SERVICE BULLETIN LA-V75-002

Product: Underground VHF Line Amplifier + Ethernet

Subject: Applying conservative Ethernet over Coax (EoC) settings

Date: 1st May 2021

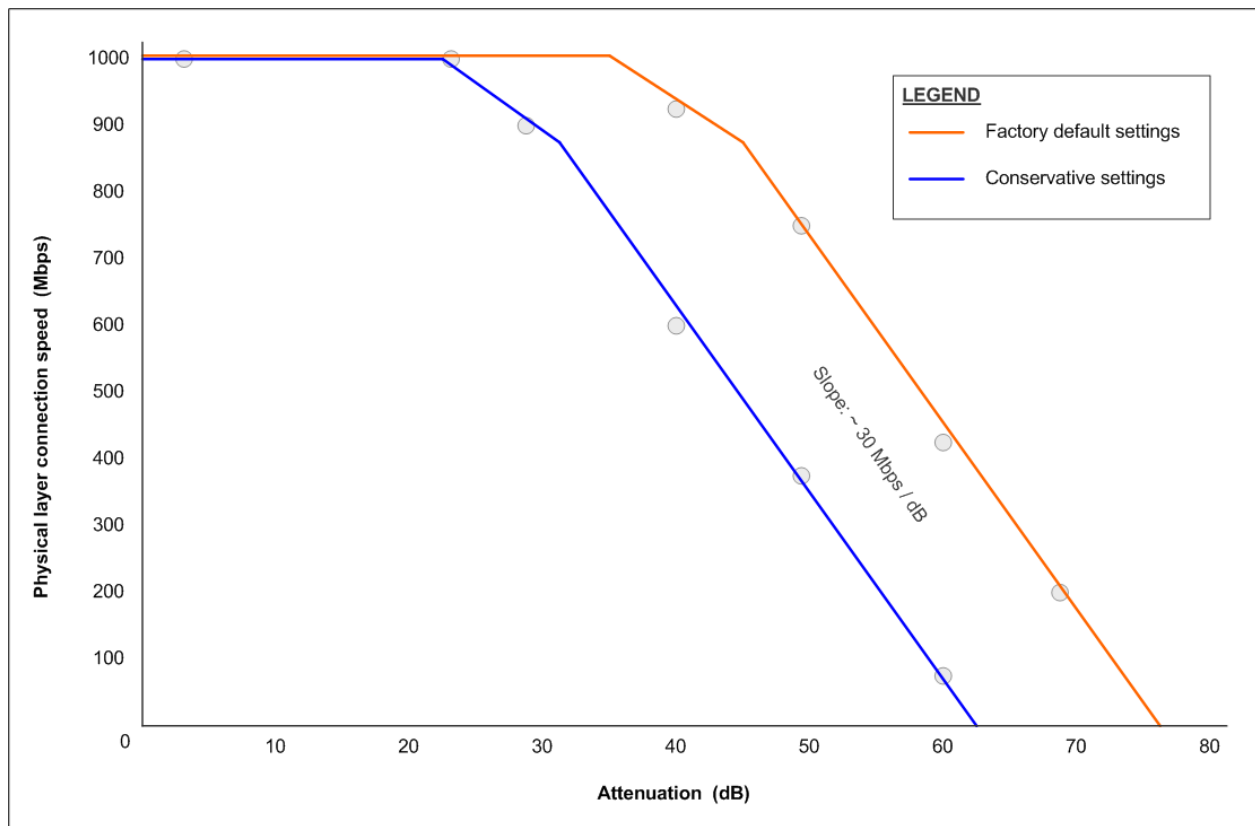
The reduced link budget has an effect on physical layer throughput, as illustrated below¹.

¹ The charts are shown for an ideal coaxial link (i.e. non leaky coaxial cable and no external noise).
